Pentium® II Xeon™ Processor Specification Update

Release Date: June 1998

Order Number: 243776-001

The Pentium® II Xeon™ processor may contain design defects or errors known as errata which may cause the product to deviate from published specifications. Current characterized errata are documented in this Specification Update.

Figure 1. An Example of Micro-controller Driven Thermal Management

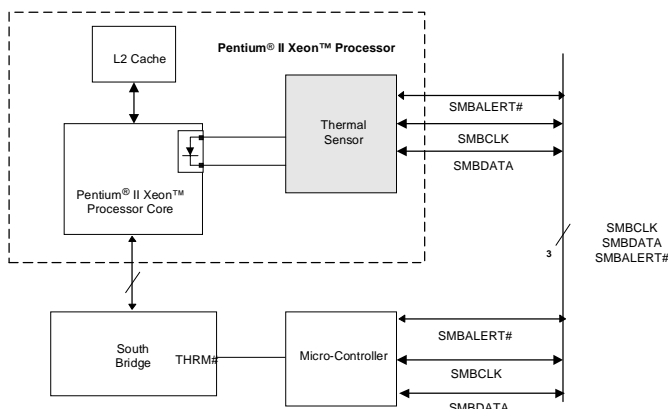
30. *Thermal Sensor May Assert SMBALERT# Incorrectly*

PROBLEM: The Pentium II Xeon processor has a thermal sensor that monitors the processor core's temperature. The thermal sensor asserts SMBALERT# if the processor temperature exceeds the temperature limits set in the Alarm Threshold Registers (T_{HIGH} , T_{LOW}). It also sets the corresponding Status Register bits to identify the cause of the interrupt. Figure 1 gives one example of the how the SMBALERT# signal could be used in a system.

Under the conditions described below, the thermal sensor incorrectly generates the SMBALERT# interrupt. **All** of the following conditions must be met to trigger a false interrupt:

1. Before servicing an interrupt from the thermal sensor, read and compare the processor thermal reading with the threshold limits (T_{HIGH} or T_{LOW}). Figures 2 and 3 provide basic flowcharts for the implementation of this workaround in an interrupt driven system.
2. If the firmware implemented polls the Status Register only, then before taking any action, re-read the temperature register and do a comparison with the alarm

threshold limits (T_{HIGH} or T_{LOW}) to determine if the value is actually still within the temperature window.

3. Use a temperature polling scheme to monitor the processor temperature.
